14. DESCRIPTION OF AMENDMENT/MODIFICATION (Organized by UCF section headings, including solicitation/contract subject matter where feasible.) N40085-15-Q-7537 REPAIR OIL WATER SEPARATOR PUMP NO. 7 DISCHARGE LINE, BUILDING 633, PHILADELPHIA NAVAL BUSINESS CENTER (PNBC), PHILADELPHIA, PA ** THIS AMENDMENT MUST BE ACKNOWLEDGED WITH YOUR QUOTE **				
Except as provided herein, all terms and conditions of the document referenced in Item 9A or 10A, as heretofore changed, remains unchanged and in full force and effect.				
15A. NAME AND TITLE OF SIGNER (Type or print)		16A. NAME AND TITLE OF CONTRACTING OFFICER (Type or print) DAVID A. RHOADS / CONTRACT SPECIALIST TEL: (215) 897-4345 EMAIL: david.rhoads@navy.mil		
15B. CONTRACTOR/OFFEROR (Signature of person authorized to sign)	15C. DATE SIGNED	16B. UNITED STATES OF AMERICA BY (Signature of Contracting Officer)	16C. DATE SIGNED 22-May-2015

THE PURPOSE OF THIS AMENDMENT IS TO PROVIDE RESPONSES TO SUBMITTED REQUEST FOR INFORMATION (RFI).

BUILDING NO. 633-FLOOR PLAN AND PARTIAL SITE PLAN

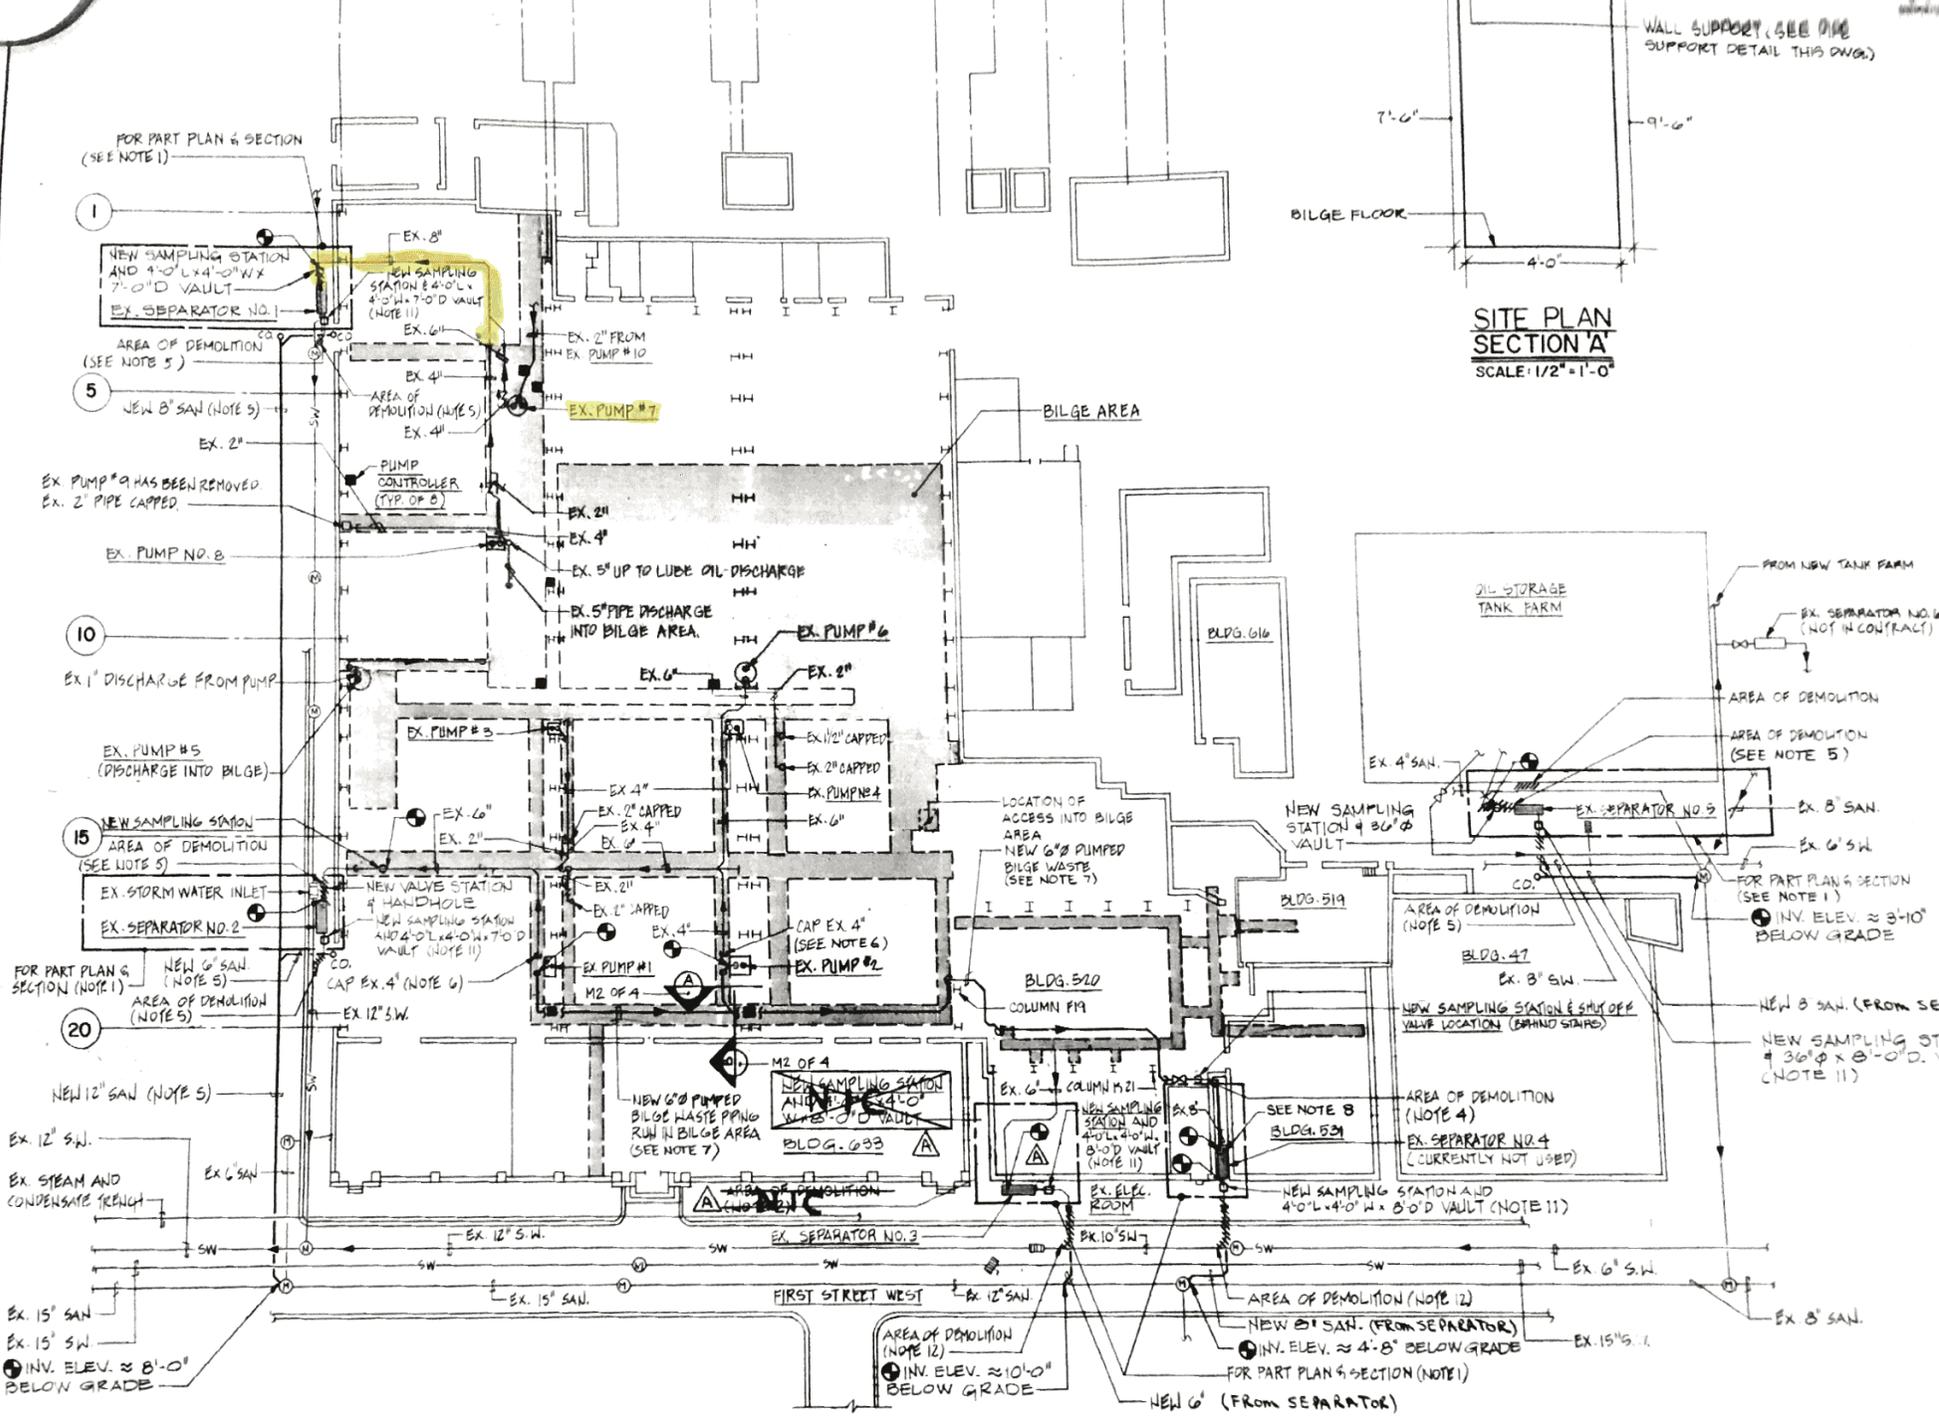
Q8. How thick should the replacement concrete be?

Q9. How deep is the broken line?

A8. The print is showing 8" thick in the area and new concrete should conform with existing height.

A9. Approximately 3-1/2 to 5 feet
